Wellan Tel 01608 685753	Wellan House, Aylesmore, Works, CV36 5EJ
Scale NTS Proj No 14-215	Title MARK-UP OF UNSTABLE WALLS
Date APRIL '16 Drg No SK/08	Project FORMER BURGESS BUILDING CANAL STREET, BANBURY

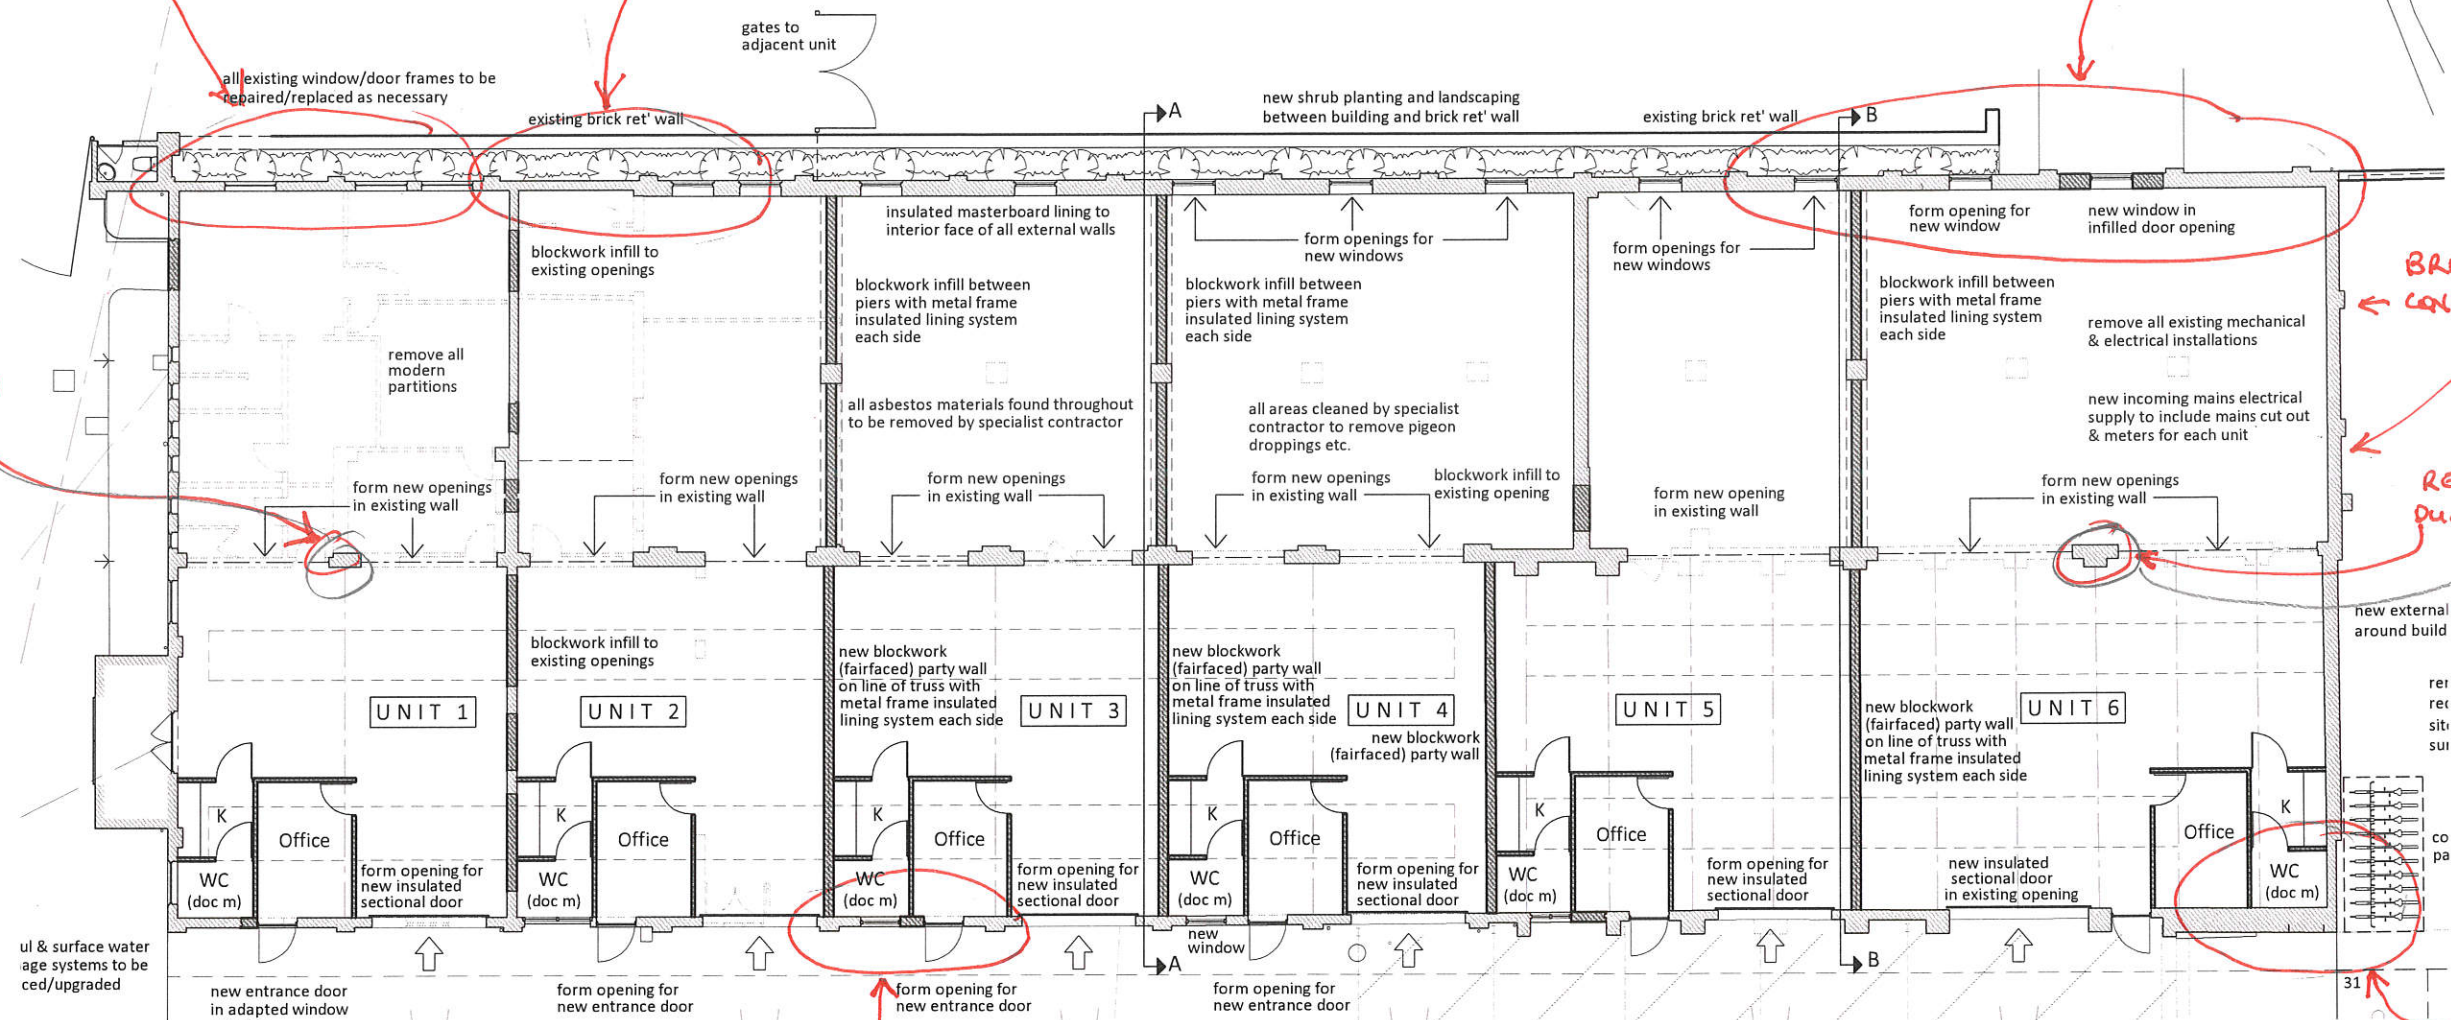
ALL OF STRUCTURE SHOULD BE REGARDED AS POTENTIALLY UNSTABLE DURING & AFTER ROOF. TEMPORARY WORKS WILL BE REQUIRED.

- 1) MANY BRICKWORK PANELS HAVE BEEN REMOVED ON SOUTH ELEVATION. OPENINGS HAVE BEEN INFILLED OR OPENINGS MADE & BRICKWORK IS IN POOR CONDITION. SOME ADDITIONAL PANELS ARE LIKELY TO REQUIRE REBUILDING.
- 2) OPENINGS TO BE MADE FOR INDUSTRIAL DOOR IN SOUTH ELEVATION WILL REQUIRE STEEL TRIMMING.

POSSIBLY REQUIRES REBUILDING

REQUIRES REBUILDING DUE TO INSTABILITY OF BRICKWORK LOCALLY.

REQUIRES REBUILDING DUE TO LEAN. DANGEROUSLY UNSTABLE WHEN ROOF IS REMOVED.

REQUIRES REBUILDING DUE TO LEAN

BRICKWORK IN POOR CONDITION

REQUIRES REBUILDING DUE TO LEAN

REQUIRES REBUILDING DUE TO LEAN.

REQUIRES LOCAL REBUILDING

REQUIRES REBUILDING DUE TO LEAN. (CAUSED BY ROOF COLLAPSE?)
